Re: Application of Devon Energy Production Company, L.P. for
administrative approval of an unorthodox oil well
location:

Well: Eagle 35H Fed. Well No. 14
Location: 2560 feet FNL & 760 feet FEL
Well Unit: SEMNE~~X~~ of Section 35, Township 17 South,
Range 27 East, NMPM, Eddy County, New
Mexico

Administrative application reference No. pMES0-319250237

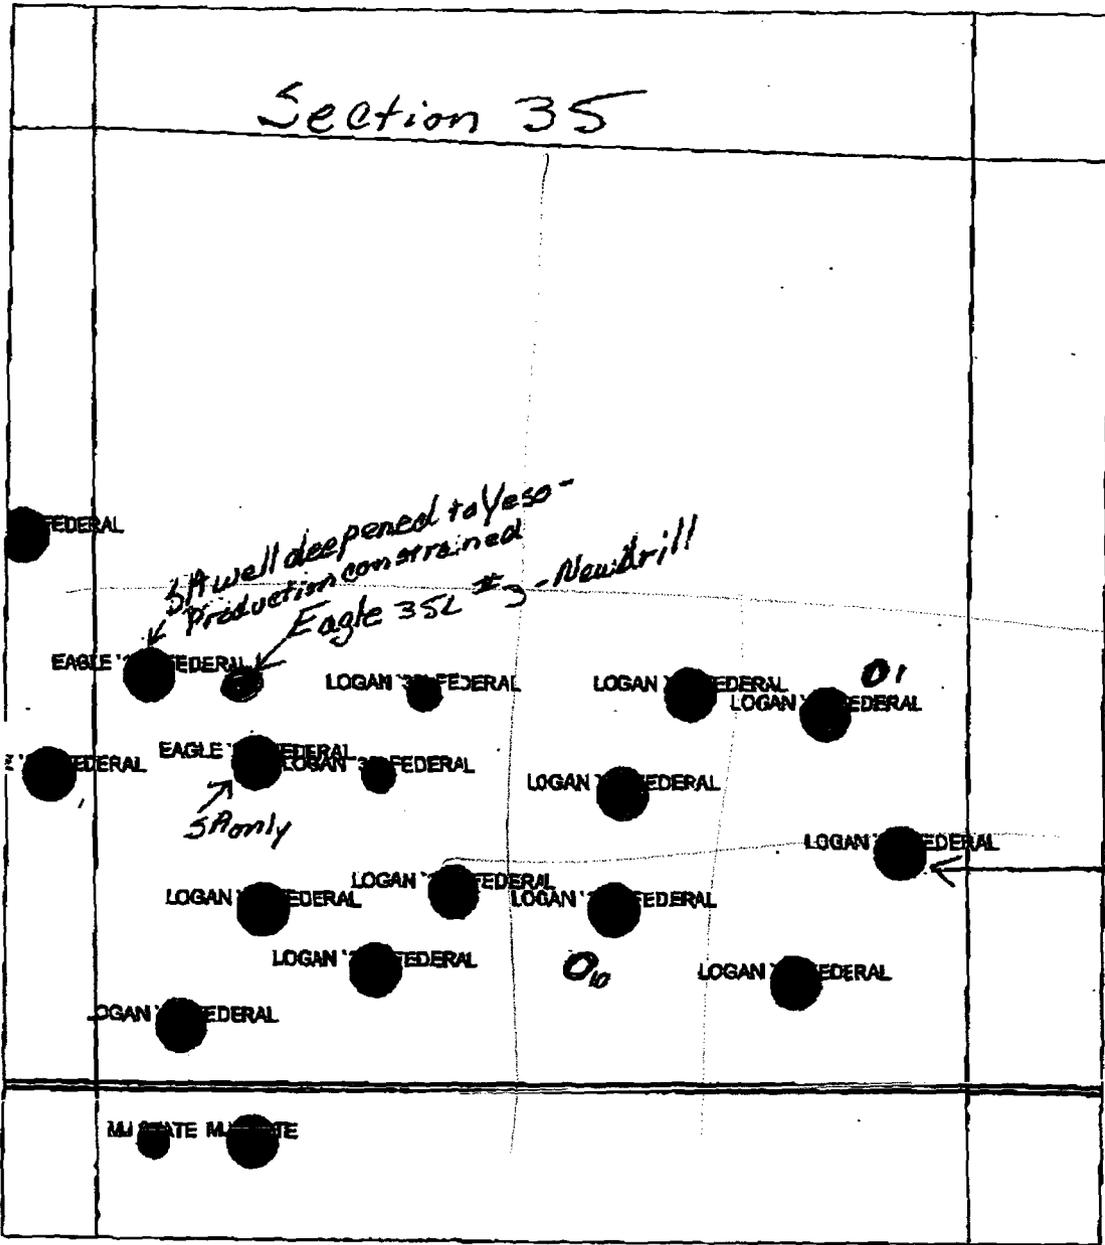
After reviewing this application along with your supplemental data dated 8/5/2003 and 8/8/2003; what is Devon's plans for the Glorieta-Yeso within its existing 40-acre oil spacing and proration unit to the immediate south comprising the NE/4 SE/4 (Unit I) of Section 35, which is currently dedicated to its Logan "35" Federal Well No. 2 (30-015-30436), located 2100' FSL & 840' FEL of Section 35?

You asked for information on Devon's plans for another well in the offsetting NE~~X~~SE~~X~~ of Section 35. Attached as Exhibit 1 is a plat showing Devon's Glorieta-Yeso wells in the S~~X~~ of Section 35. Please note: (1) The leases in the SE~~X~~ of Section 35 derive from a single federal lease, with common overriding royalty ownership; and (2) there are six Glorieta-Yeso wells in the SE~~X~~, three of which are in the N~~X~~SE~~X~~. Therefore, Devon believes that the correlative rights of the interest owners in the N~~X~~SE~~X~~ of Section 35 are adequately protected.

Devon did permit a second well in the NE~~X~~SE~~X~~ of Section 35. However, that well has not been drilled, because it would be too close to the existing well in that quarter-quarter section.¹

¹The existing well is somewhat out of the northeast-southwest drilling plan because of surface considerations.
